Road Alteration - Woodbine Avenue

Date: March 30, 2021

From: Acting Director, Traffic Management, Transportation Services

The revised lane configuration map is included in Attachment 1.

Figure 1: Artist representation of revised lane configuration on Woodbine Avenue

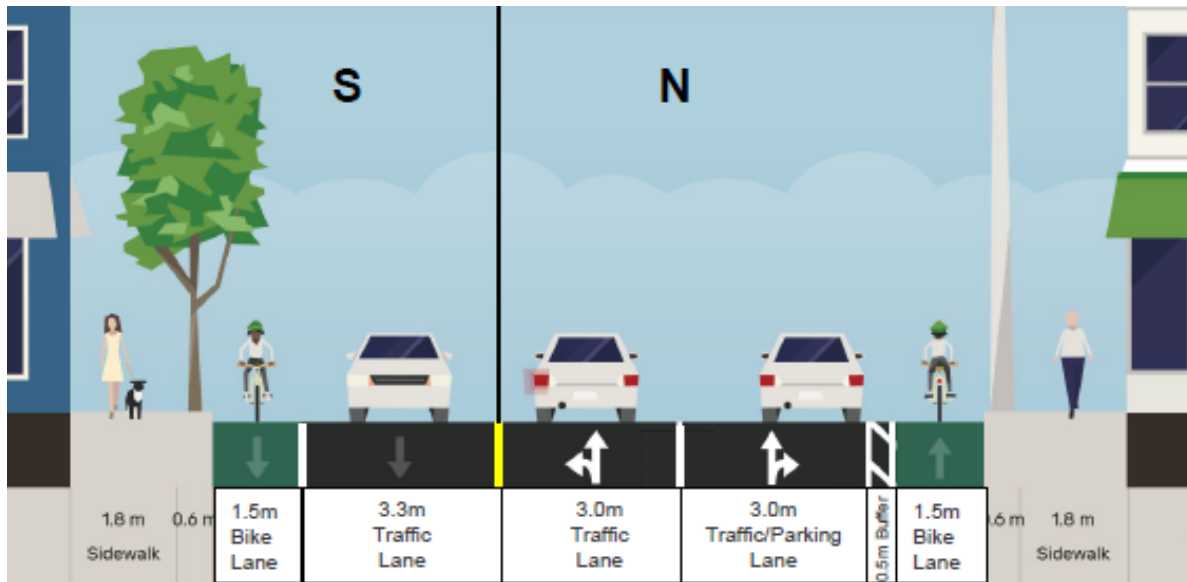
The above design includes a second northbound travel lane which would provide additional northbound capacity during the afternoon peak period and would be used for morning, off-peak, and overnight permit parking. It also includes a reduced painted buffer beside northbound cycle track which would minimize the risk of parked cars "dooring" people cycling. The installation of flexible posts within the buffer lane would enhance and better delineate the separation between the travel and bicycle lanes. Bicycle lanes in both directions would be slightly narrowed but will be within the minimum City standard for bicycle lanes. The 3.3 metre travel lane in the southbound direction is the minimum width for a Toronto Transit Commission (TTC) bus route. The northbound curb lane would be narrowed to 3.0 metres (0.3 metres below the standard minimum width).

Toronto Transit Commission (TTC) buses operate in the curb lane, however, it should be acknowledged that it will not be possible for northbound TTC buses to remain fully within their travel lane. The 0.5 metre buffer space adjacent to the parking lane would provide space for TTC buses (including overhanging mirror) to operate completely outside the northbound cycle track but not fully within their lane. During the morning peak, off-peak, and overnight hours, TTC buses would operate within the westerly northbound curb lane which is 3 metres (0.3 metres below standard as mentioned above) and may encroach into the easterly northbound traffic lane when parking is permitted.

A notable aspect of this design change is the relocation of the northbound taper/merge lane from its existing location 115 metres north of Kingston Road to approximately 75 metres north of Gerrard Street East. The location of the overhead CN rail line pillar and retaining wall contributes to geometric design constraints north of Gerrard Street East. There is currently insufficient room to implement an appropriate taper length to merge traffic from two lanes of travel back to one. For a roadway with a speed limit of 50 km/h, the recommended taper length is 115 metres. The geometry of the roadway permits the installation of a 50.5 metre taper which does not provide sufficient acceleration and merge opportunity.

The vertical grade north of Gerrard Street East also reduces a driver's visibility of the lane ending. Queue spillover into the Woodbine Avenue and Gerrard Avenue East intersection would be expected, resulting in the obstruction of east/west traffic along Gerrard Street East; and, reduced opportunity for northbound motorists to transition safely from the terminated northbound curb lane.

The reduced taper and lateral shift could result in increased sideswipe and rear end collisions. Poor lane alignment, lateral shift and poor visibility of the far-side of the intersection could result in head-on collisions between southbound left-turning vehicles and northbound through vehicles. The above risks of the proposed design cannot be fully mitigated due to the constrained roadway width and topography of Woodbine Avenue north of Gerrard Street East.

The revised design will also require the removal of the dedicated northbound left-turn lane at Woodbine Avenue and Gerrard Street East, and as a result, the northbound left lane becomes a shared through/left-turn lane. As such, the traffic capacity through the intersection will not double with the addition of a second travel lane. Since this lane will now be shared, when a vehicle is waiting to turn left, traffic traveling through the intersection would need to wait behind the left turning vehicle.

If despite staff's recommendation, City Council decides to proceed with the attached design, staff recommend a reduced speed limit from 50km/h to 40km/h due to the sub-standard lane widths, limited separation between motor vehicles and bicycles and sub-standard geometric design. This would encourage motorists to travel slower reducing any potential collision impacts to traffic and improve safety for people walking and cycling.

In addition to the above, it is also recommended that an assessment of the signal timing operation at the intersection of Woodbine Avenue and Gerrard Street East be conducted to determine the optimal signal timing for the revised lane configuration at the intersection.

**WOODBINE AVE:
 GERRARD ST E - KINGSTON RD
 PROPOSED PAVEMENT MARKINGS PLAN
 (SHEET 2 of 3)**

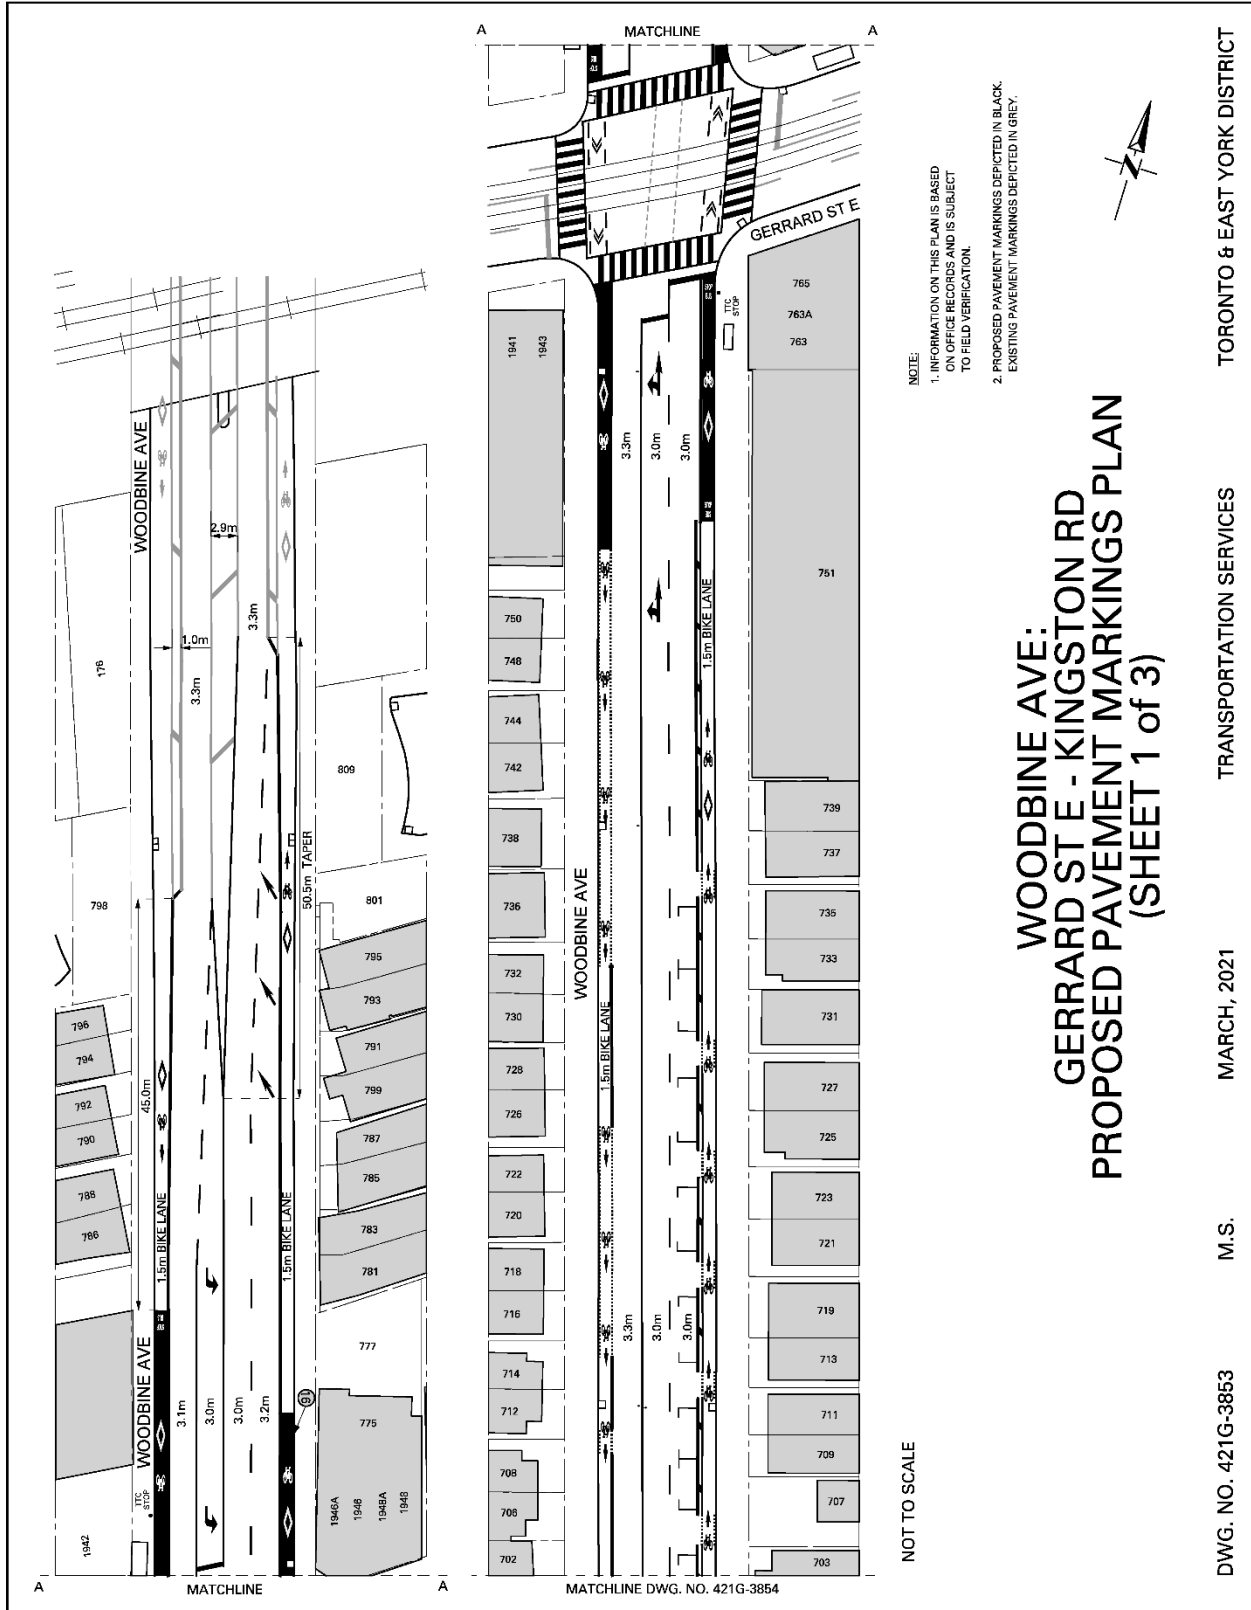
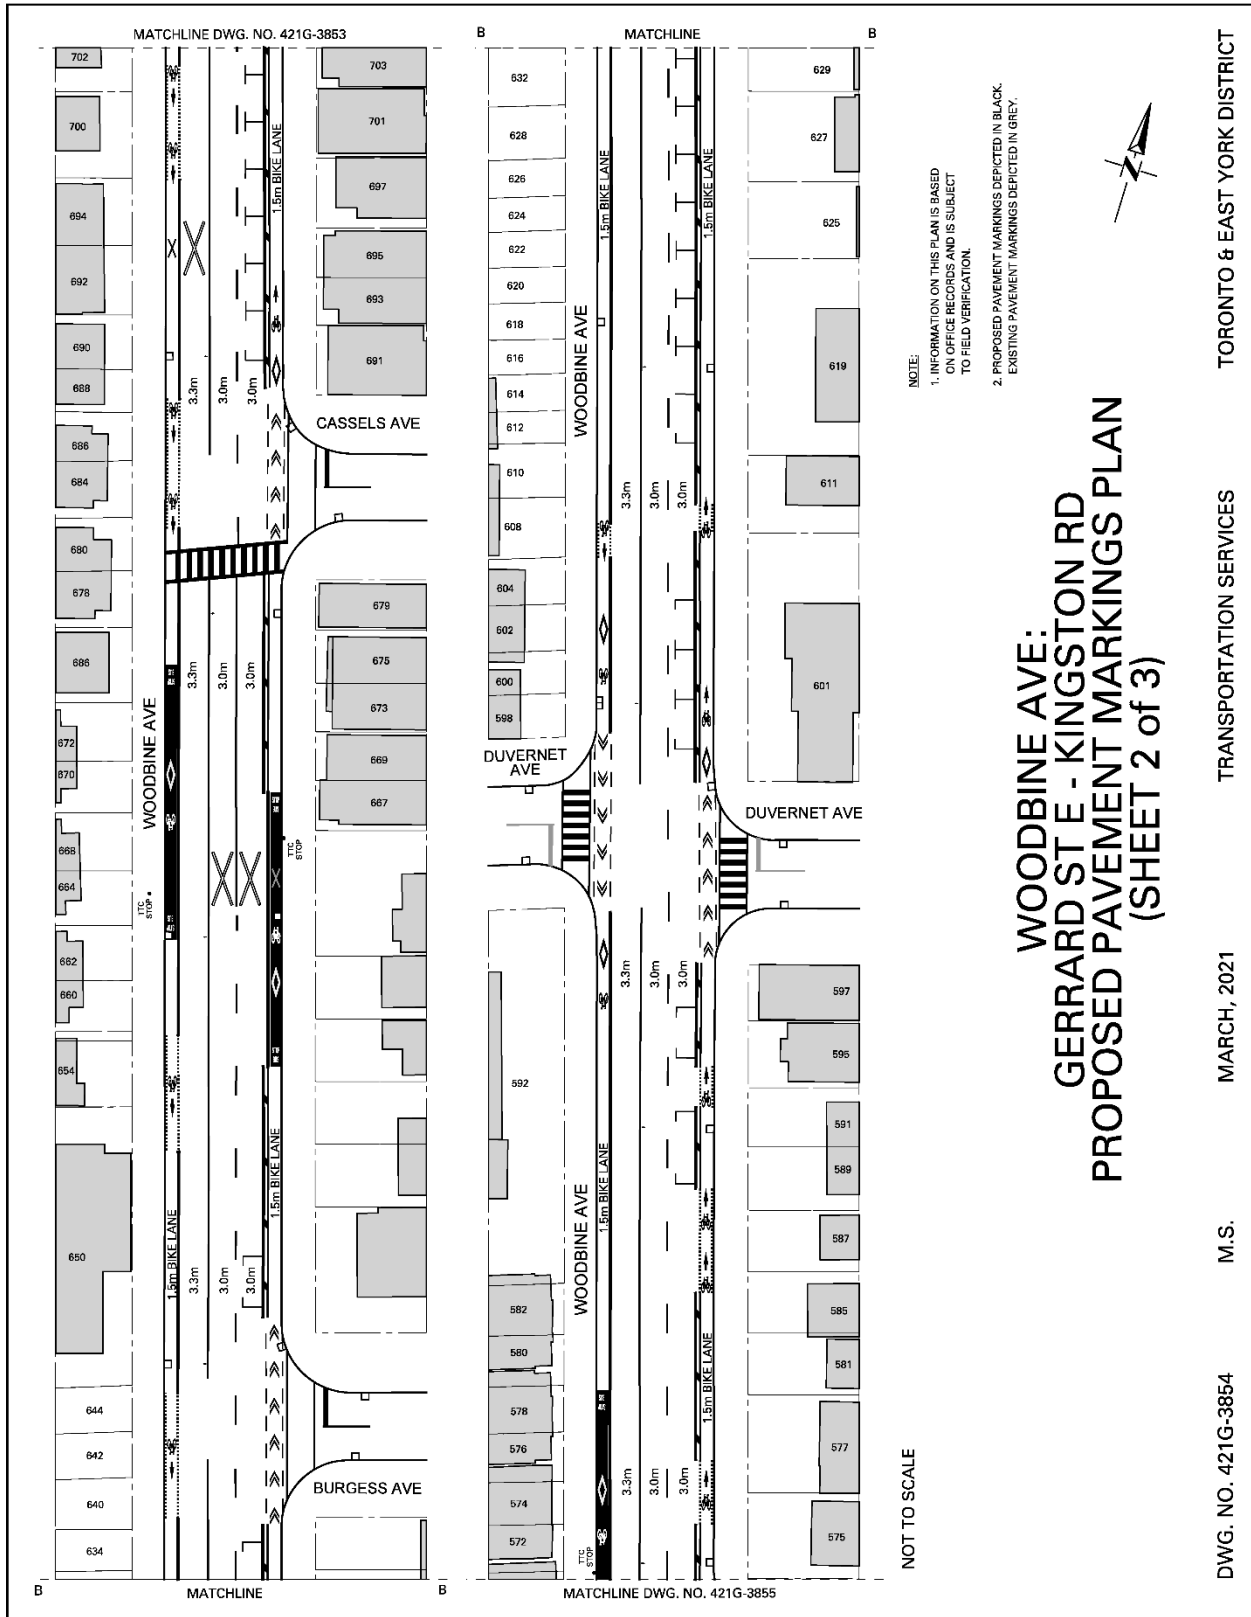
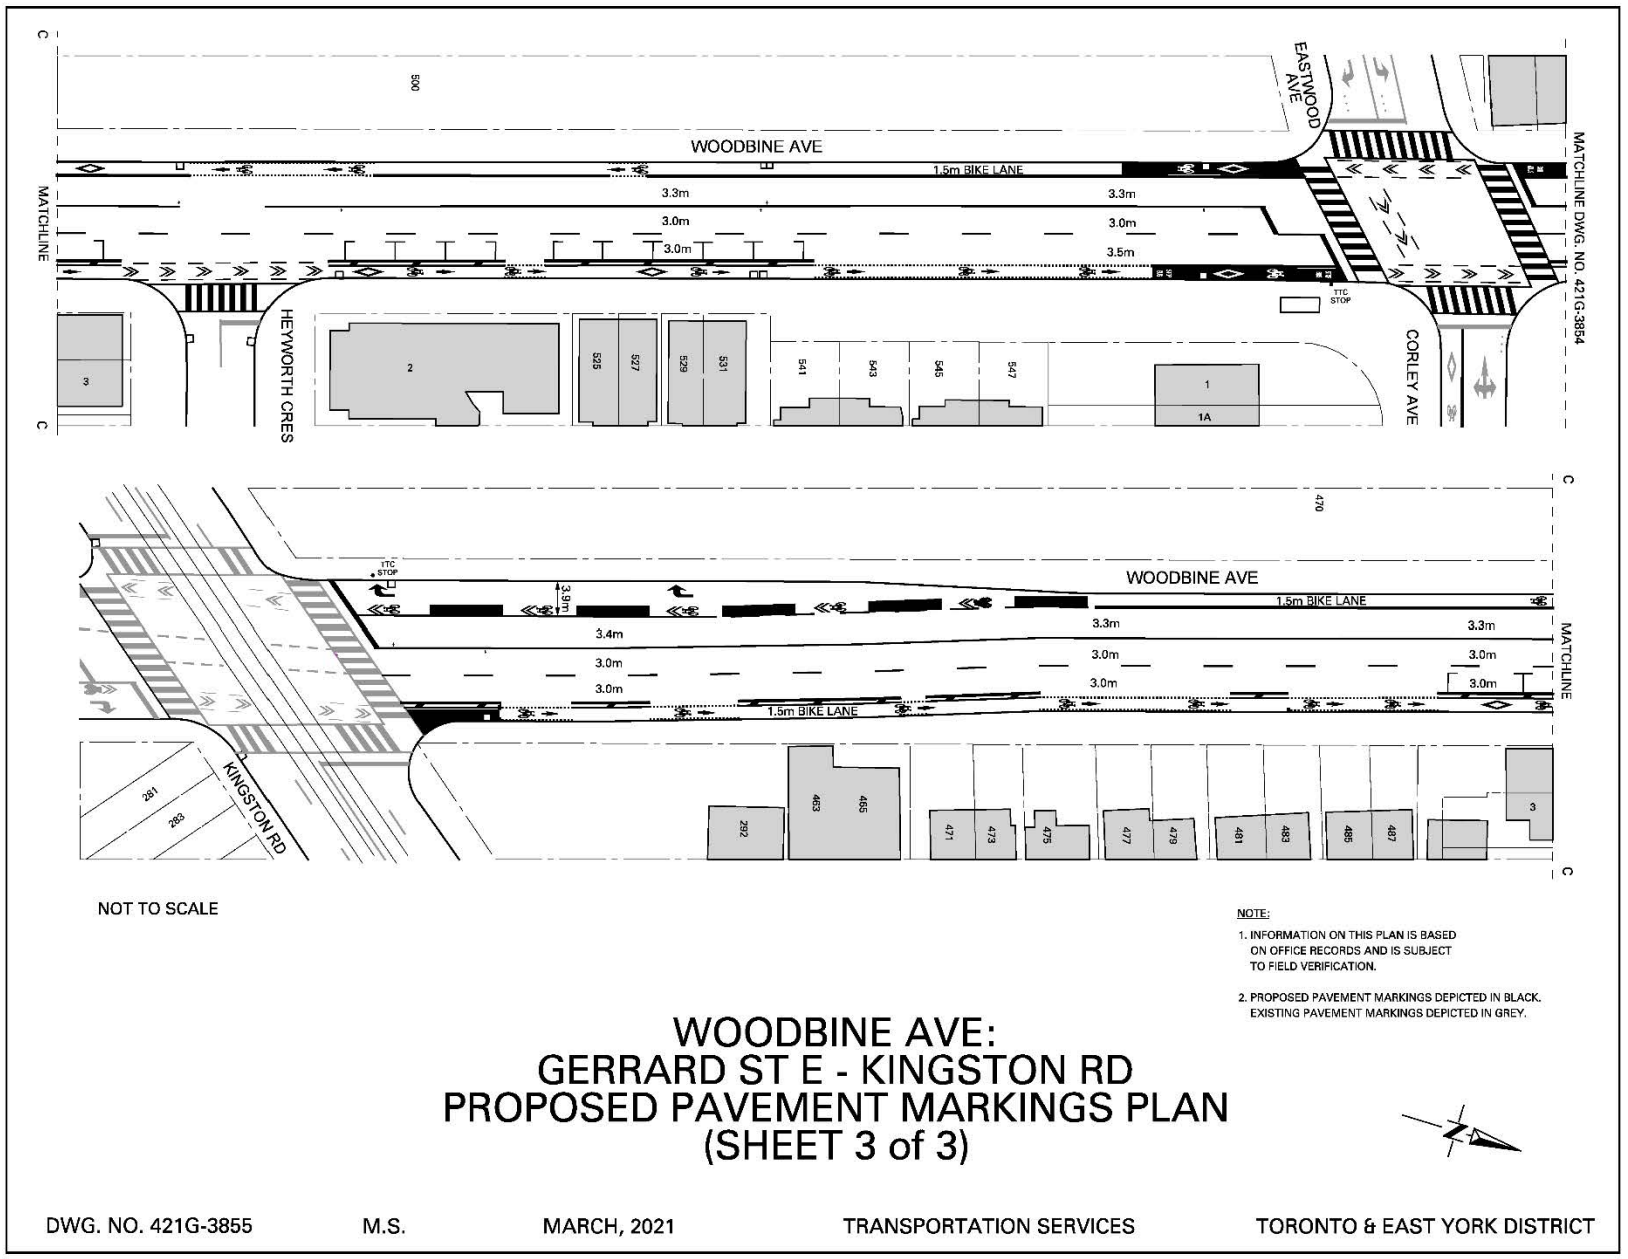
Additionally, there has not been any previous installation in the City of Toronto of on-street bicycle lanes with time restricted parking located between the motor vehicle travel lane and the bicycle lane. This arrangement will need to be closely monitored for cycling safety.

Notwithstanding, should City Council choose to proceed with this design, staff recommends the installation of traffic monitoring cameras to better enable monitoring of the revised configuration.
